MEMO

To: Planning Commission

From: Ryan Harris, Staff Planner

RE: **Santaquin Dentistry and Canyon Creek Orthodontics Additional Sign Request**

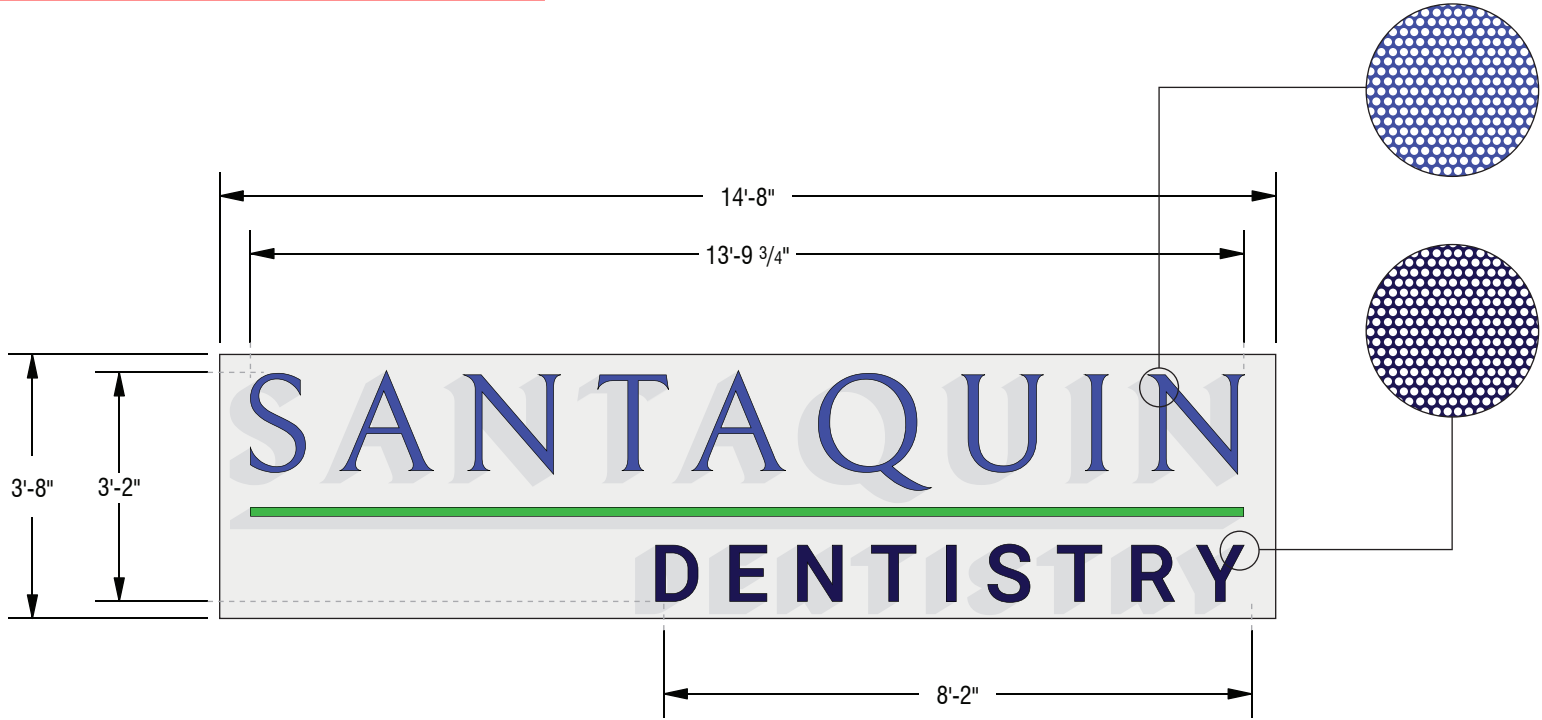
Santaquin Dentistry and Canyon Creek Orthodontics will be located in Ridley's Pad Site C building and will occupy the west portion of the building. The applicant submitted a sign permit on September 10, 2021 and is proposing four signs. There will be four signs, two on the front (south elevation) and two on the rear (north elevation) of the building. If there is a sign on the rear of the building, Planning Commission approval is needed. The rear of the building on Ridley's Pad Site C is the elevation facing the parking lot. The front of the building is considered the elevation facing Main Street.

Santaquin City Code 11.44.080.E.5 says, "Wall Specified: Buildings or businesses with exposure on the side(s) and front may choose which wall to mount their sign upon. Signs are allowed on the rear of the building with planning commission approval.

The proposed signs meet all requirements found in SCC 10.44.080.E.2. The proposed signs are not considered cabinet signs. The letters are all individually lite and attached to the background. The background will not be lite. The signs also meet all area requirements for the primary and secondary walls.
